Progress Energy

**Subject: Brunswick Steam Electric Plant, Unit Nos. 1 and 2
Docket Nos. 50-325 and 50-324/License Nos. DPR-71 and DPR-62
Response to Request for Additional Information Regarding Relief Request
RR-36, Use of Ultrasonic Examinations in Lieu of Radiographic Non-
Destructive Examinations (NRC TAC Nos. MC8064 and MC8065)**

Response to Request for Additional Information Regarding Relief Request RR-36

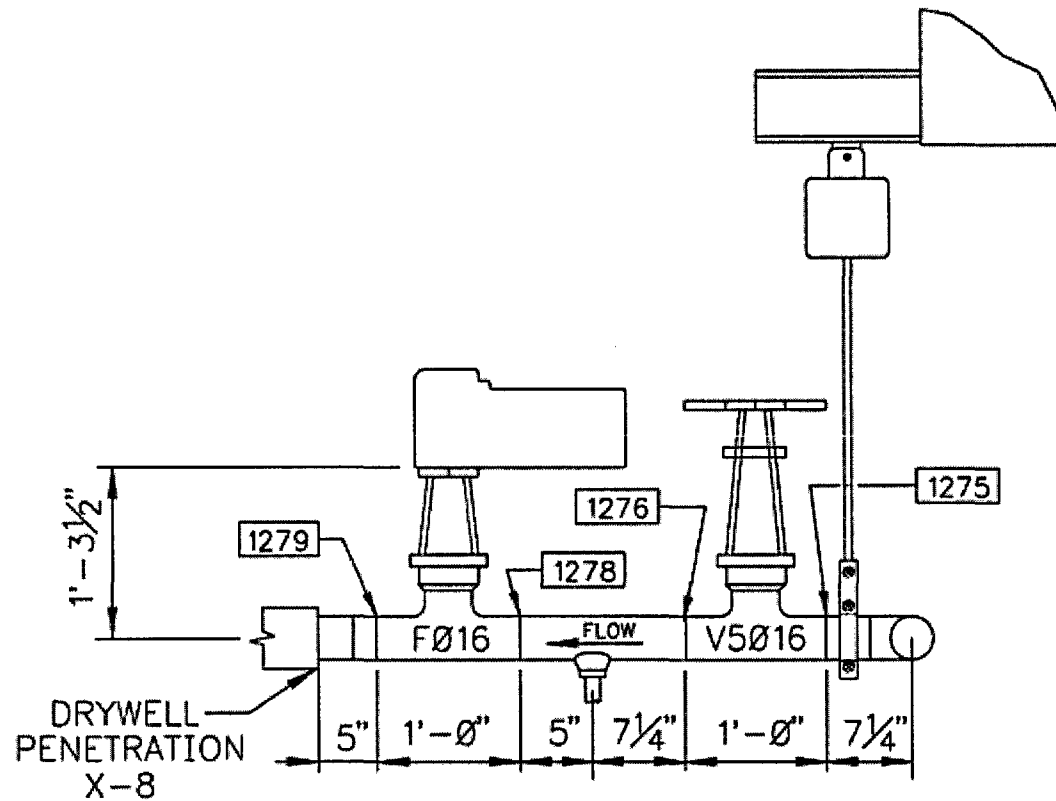
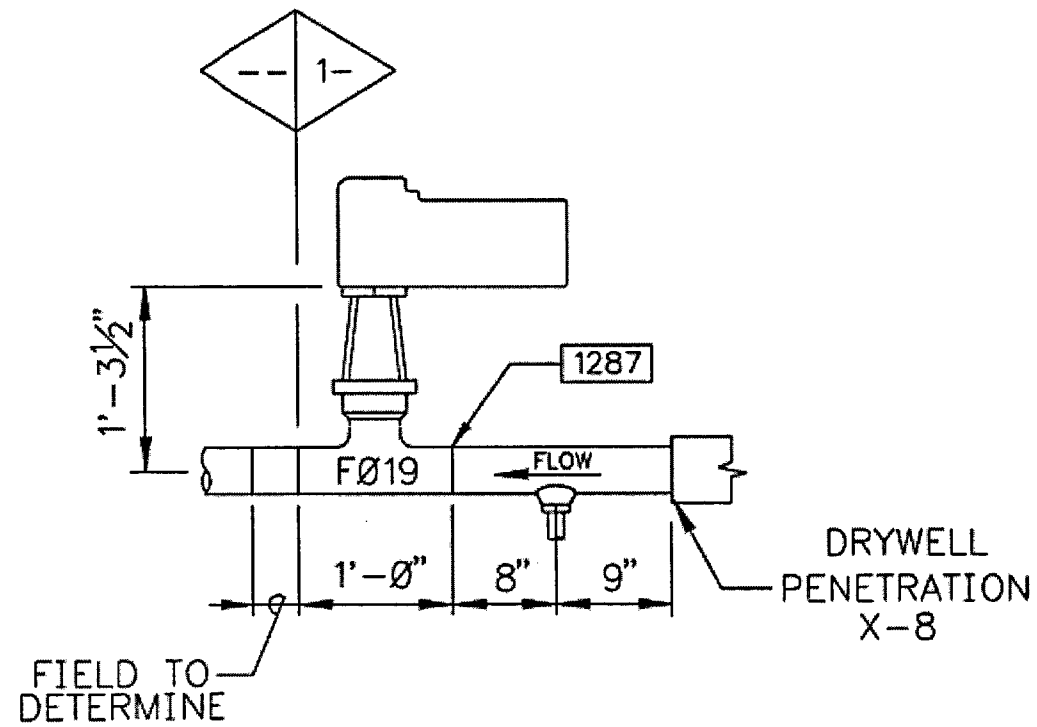
The request is to record indications using less precise location criteria than the permanent record provided by RT and the criteria in Code Case N-659. The permanent record provides a baseline for geometric, metallurgical and fabrication indications. Discuss how the proposed manual phased array system meets the intent of the Code and the code case requirement for providing a permanent retrievable record for look-backs should a problem be identified in any of the subject welds after being returned to service. For the subject welds, provide information on access and limitations hindering the use of an automated data acquisition system, automated positioning with manual movement or RT. Provide a cross section sketch of the welds showing the restrictions.

As previously stated, in order to expedite review and approval of the request for relief to support upcoming BSEP, Unit 1 refueling outage activities, CP&L has revised the scope of Relief Request RR-36 to apply only to the specific welds associated with replacement of the 1B21-F016 and 1B21-F019 main steam drain line isolation valves during the upcoming Unit 1 refueling outage. The plant modification replacing the 1B21-F016 and 1B21-F019 main steam drain line isolation valves will install three valves in a system that was previously designed for two valves. As a result, the unobstructed length of piping adjacent to each valve will be significantly less than originally designed. Manual pipe scanners are available to allow encoding of data, but are limited to a minimum pipe diameter of 4 inches. The pipe containing the welds addressed by this relief is 3 inches in diameter. If used, scanners need to be mounted adjacent to the weld on a smooth pipe surface. For off-the-shelf scanning equipment, the typical clearance needed is 12 to 18 inches to allow the scanner arm to extend and retract. The configurations of the welds addressed in this request allow a maximum clearance of less than 8 inches. These welds are pipe-to-valve configurations which limit scanner placement to the pipe side due to the irregular shaped surfaces of the valves in question. The pipe side access restriction for each weld is discussed below:

- | | |

| 1-B21-1275 | Welded in-tee fitting upstream of weld |
| 1-B21-1276 | Welded sockolet downstream of weld |
| 1-B21-1278 | Welded sockolet upstream of weld |
| 1-B21-1279 | Drywell penetration downstream of weld |
| 1-B21-1287 | Welded sockolet upstream of weld |

The drawings shown in Attachments 1 and 2 show the access restrictions discussed above. The access restrictions listed above do not prohibit the use of RT; however, the use of UT will allow inspections to take place in parallel with other outage activities within the vicinity of the MSIV drain line. RT will require evacuation of the drywell and MSIV pit for a minimum of four hours for each location. Repairs or RT reshots would result in additional impact to the outage schedule. There is also less risk of accidental radiation exposure using UT versus RT.
